BRAVIA IP Control Specification

Specification changes for RED-DA support

Document version 1.0.0

IP control settings UI

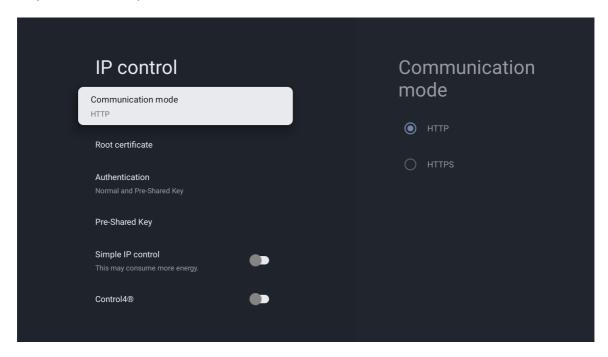
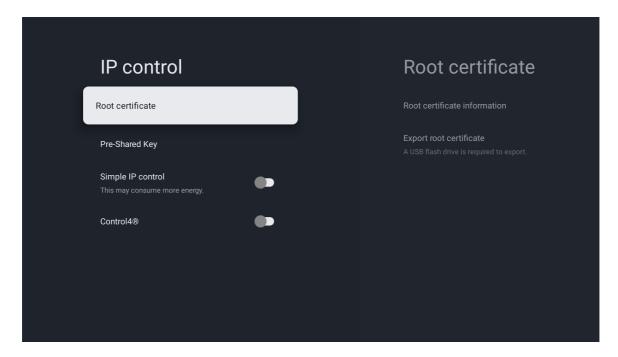
The following settings UI on BRAVIA is changed.

- Case A (PKG After 7/E)
 - Add: Communication mode
 - o Add: Root certificate
- Case B
 - o Add: Root certificate
 - o Delete: Authentication

In Case A, these settings values are inherited from "PKG Before 7/E" after updating to "PKG After 7/E"

Control remotely

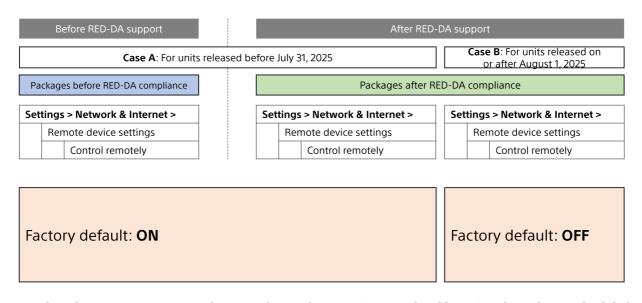
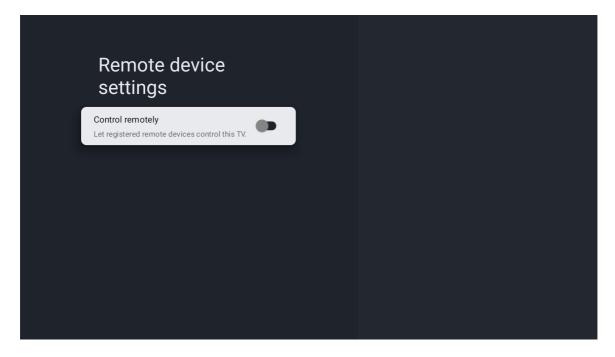
To comply with RED-DA requirements, the "Control remotely" setting (IP control enablement) is changed to OFF by default.

Even for on-device communication, it is necessary to enable the setting.

Case B: Factory default: OFF

Authentication & Pre-Shared Key

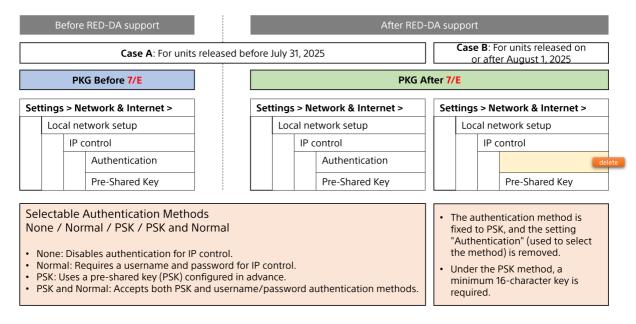
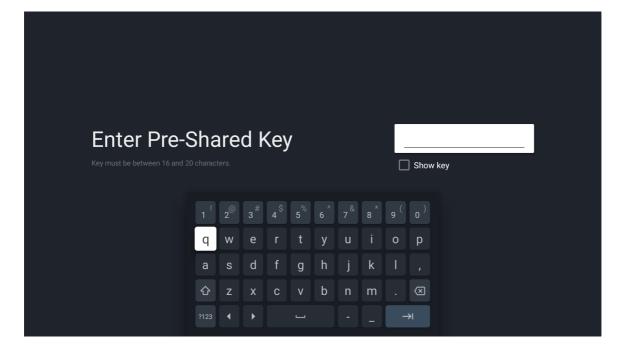
Starting from units launched on or after August 1, 2025, the pre-shared key and its specifications are revised.

Case B: Pre-shared key requires minimum 16 characters

HTTPS communication

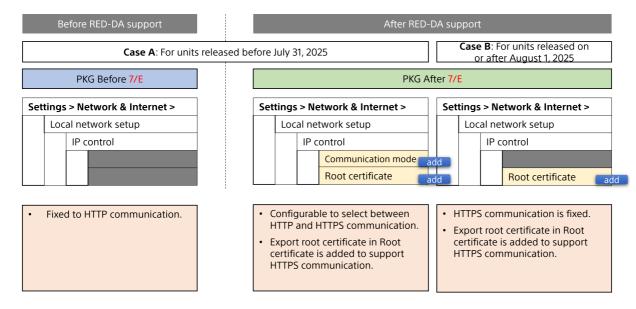
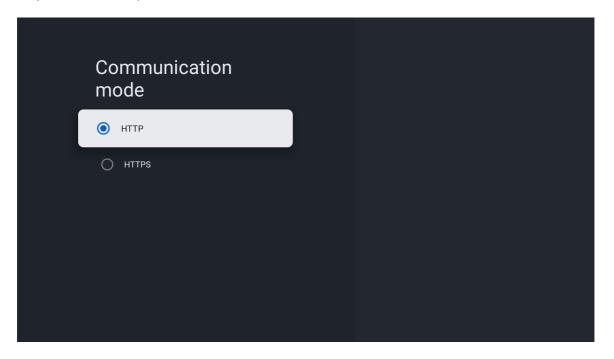
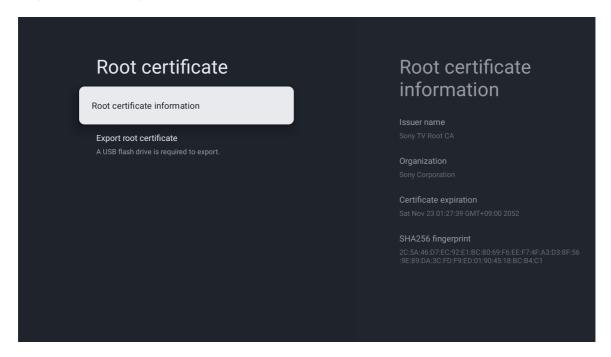
For units released on or after August 1, 2025, HTTPS communication is mandatory to comply with RED-DA regulations.

As part of the transition to HTTPS communication, the following specification changes are implemented.

1. Support is changed to communication	Only HTTP communication	Support both HTTP and HTTPS	Support is changed to HTTPS communication only.	Support HTTPS on counterpart devices and proceed with market release. In locations where existing models and RED DAcompatible models are mixed, introduce the option to select HTTP/HTTPS for each display. (Current models: To allow selection of HTTPS/HTTP after receiving an OTA update.)

2. Introduction of server certificate	Not to support	Support to introduce Server Certificate as HTTPS communication		Addition of Procedures: 1. Export the unique server certificate from each set to a USB. 2. Install the server certificates of all connected Displays on the PC. 3. Configure the certificates in the browsers or other tools being used. (Since these are self-signed certificates, it may be necessary to ignore warnings.) 4. Start communication.

The need to switch to HTTPS communication is only required when BRAVIA communicates with external PCs or servers. For on-device communication using Web API (REST API), HTTP communication will continue to be used even after RED-DA compliance.
